Electrical Energy & Safety Audit Report of Mangaldoi Commerce College, Mangaldoi, Assam

Audit Period: 31/03/2022-04/04/2022

Audited by: MRINMOY BORUAH ENGINEERING

Photo: 100A Fuse at grid supply incomer

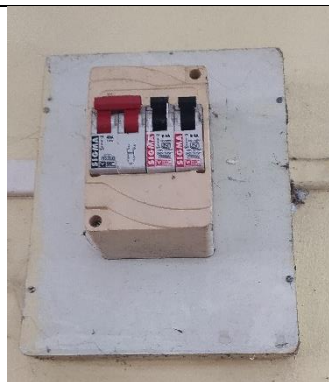
- The primary source of power supply to the college campus is from an Overhead LT Grid Supply cable.
- The LT grid supply cable is fed to a 100A Fuse, mounted on a wall at the corridor outside the Office room. There is no MCB/MCCB protection at the LT Grid supply input.

- 1) An MCB switch of appropriate rating should be installed at the LT Grid supply input, in place of the existing 100A fuse. The fuse protection system currently being used is not sufficient to ensure safety of the power distribution system of the college.
- 2) A distribution board (DB) should be installed for power distribution to the various rooms of the college campus. This main distribution board should have MCB switches of appropriate rating for each of the circuits outgoing to the different rooms of the college.
- 3) The DBs installed at the various rooms of the college have isolators as their Main Incomer Switch. These isolators should be replaced by MCB switches of appropriate ratings.
- 4) A complete revamping of the earth arrangement is necessary.

Photo: DB at Room #9:
1 x 40A DP Isolator (Main Incomer)
2 x 6A SP MCBs (Outgoing)

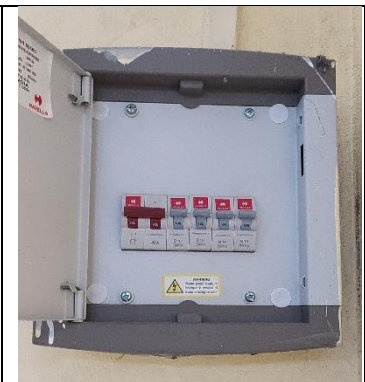
- Multiple tapplings are taken from these outgoing circuits to provide power supply to the different rooms. There are distribution boxes (DBs) installed at the different rooms for their power distribution. The Main incomer switch of each of these DBs are isolators. These isolators do not provide any protection for these circuits.
